Product Change Notification / RMES-15BFRM526

CCB 6068 Final Notice: Qualification of STAR as an additional final test site for MICRF219AAYQS, MICRF219AYQS, MICRF220AYQS, MICRF219AAYQS-TR, MICRF219AYQS-TR, MICRF220AYQS-TR, and SPN111001Y-TR catalog part numbers (CPN) available in 16L QSOP (.150in) package.

PCN #: RMES-15BFRM526

CCB 6068
Pre and Post Change Summary
PCN #: RMES-15BFRM526

Pre and Post Change – Plastic Reel

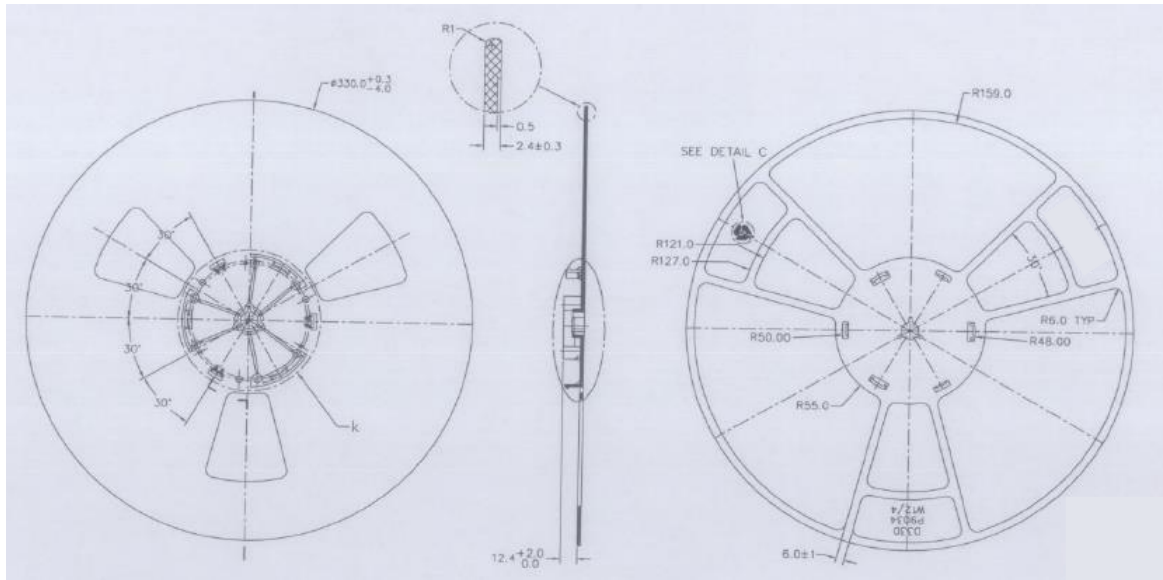
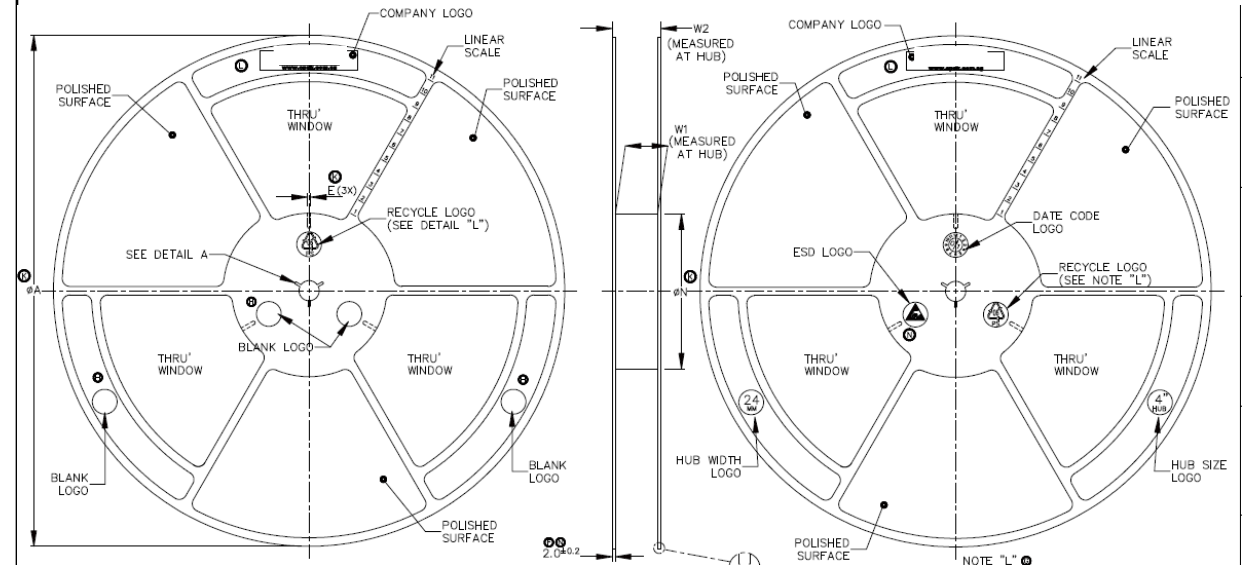
Note: No change in dimension and appearance.

Pre and Post Change – Carrier Tape

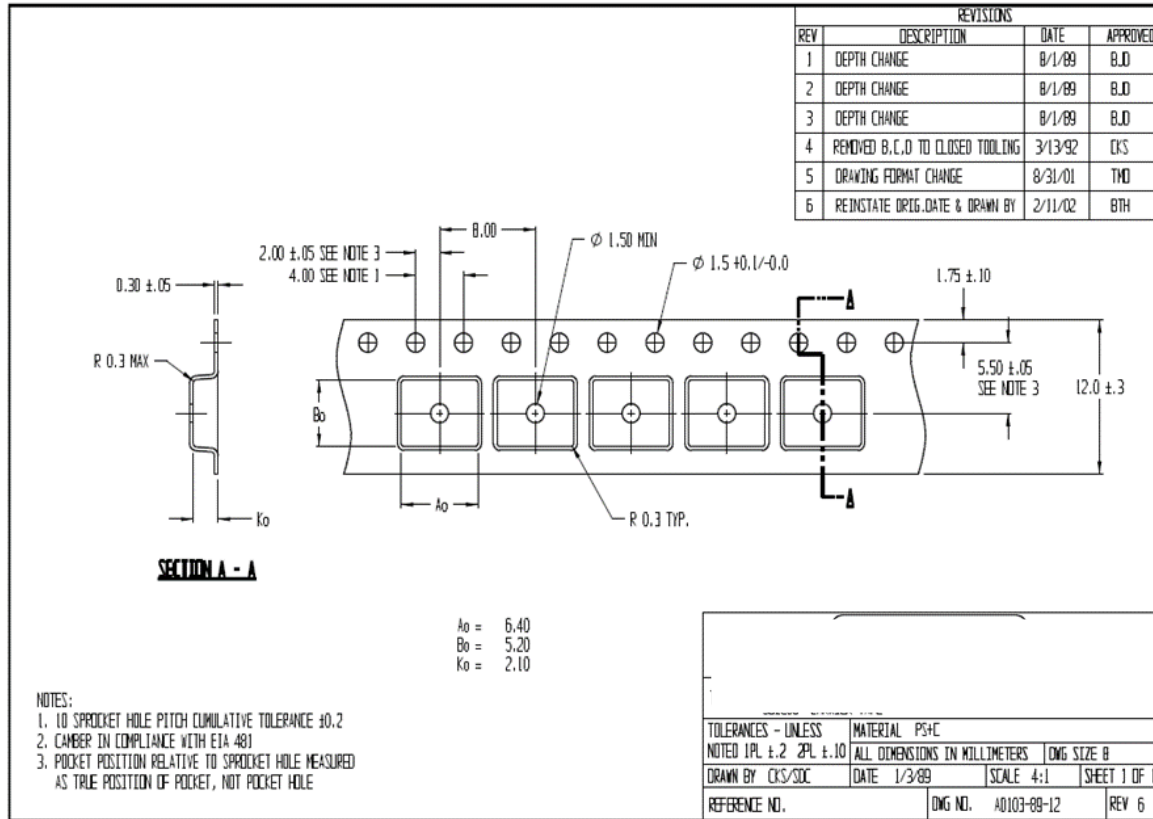
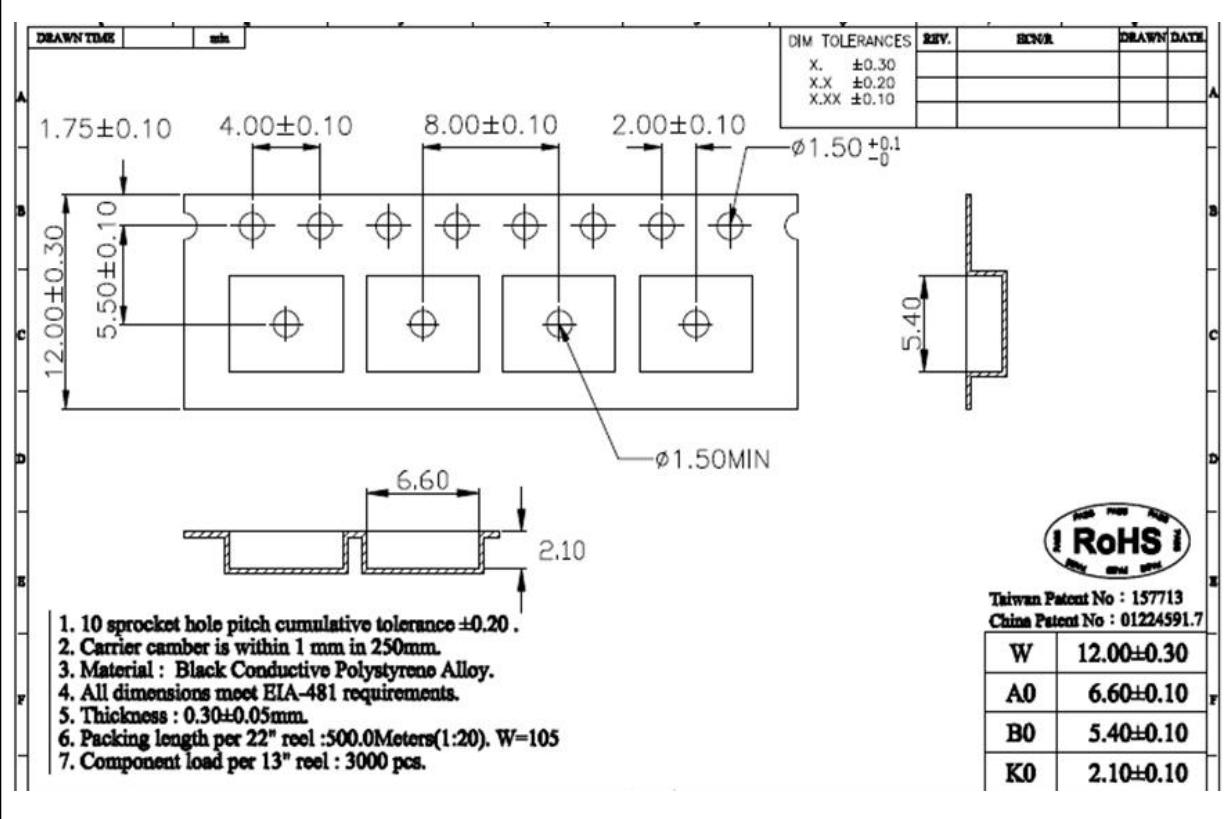
Plant	W (mm.) ± 0.3 or Specific	P (mm.) ± 0.1 or Specific	A ₀ ± 0.1 or Specific	B ₀ ± 0.1 or Specific	K ₀ ± 0.1 or Specific
UNIS	12	8	6.40	5.20	2.10
STAR	12	8	6.60	5.40	2.10

Pre and Post Change – Cover Tape

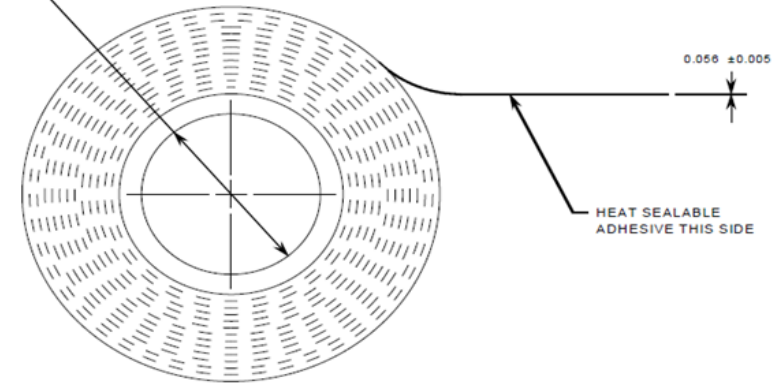
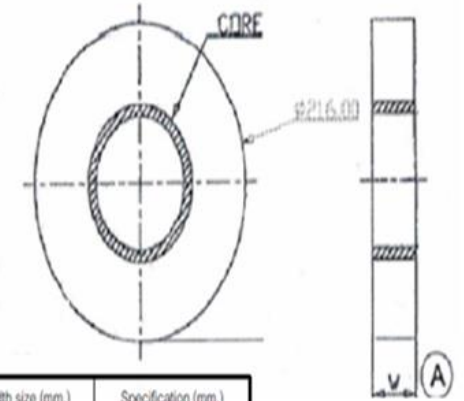
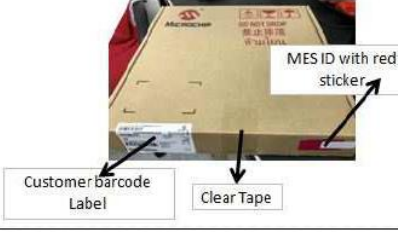
Plant	Carrier Tape Width	Cover Tape Width	Thickness	Color	Sealing mythology
UNIS	16mm	13.3 +/-0.1mm	0.056+/-0.005	Clear	Heat sealing
STAR	16mm	13.3 +/-0.2mm	0.050+/-0.005	Clear	Heat sealing

Pre and Post Change – Tube

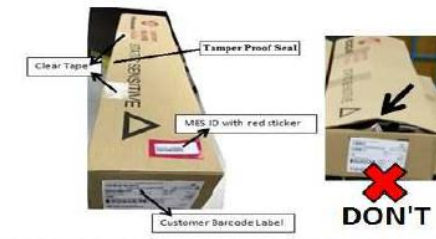
UNIS	STAR
BQM (Base Quantity Multiple)	98 units	98 units
Pin 1 orientation	<p>Pin 1 toward white stopper</p> 	<p>Pin 1 toward grey stopper</p> 
Tube Color	Clear tube	Clear tube
Plug Color	Full Tube: White – Black Partial Tube: White – Yellow	Grey-Grey
